SERVICE BULLETIN

APPLICABILITY: 2015MY Impreza WRX 2.0L DIT **NUMBER:** 11-144-14
SUBJECT: Reprogramming Files for DTCs P0420, P2610 and P0134 **DATE:** 08/27/14

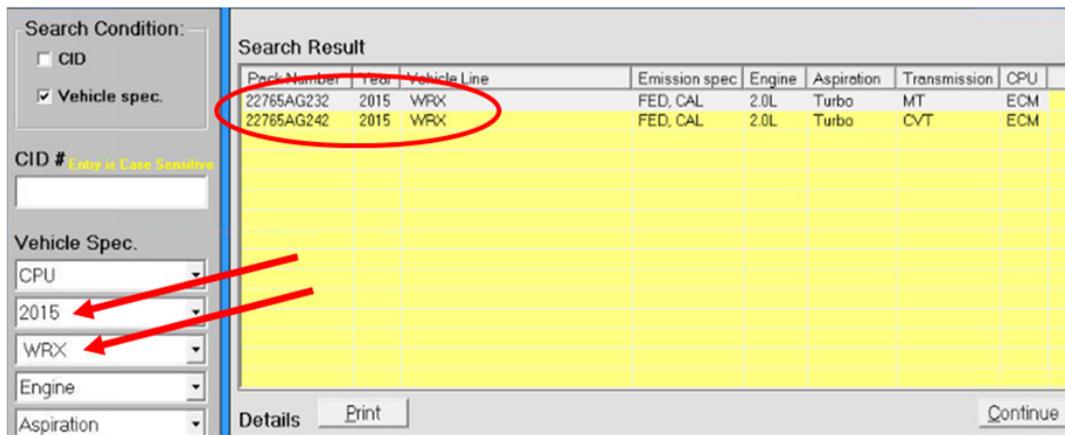
IMPORTANT: When searching in Flashwrite for these pack files, keep in mind that starting with 2015MY, the WRX is now its own model, separate from the Impreza. When searching by Vehicle spec. for applicable pack files, select the WRX from the drop-down list as shown in the screen below.
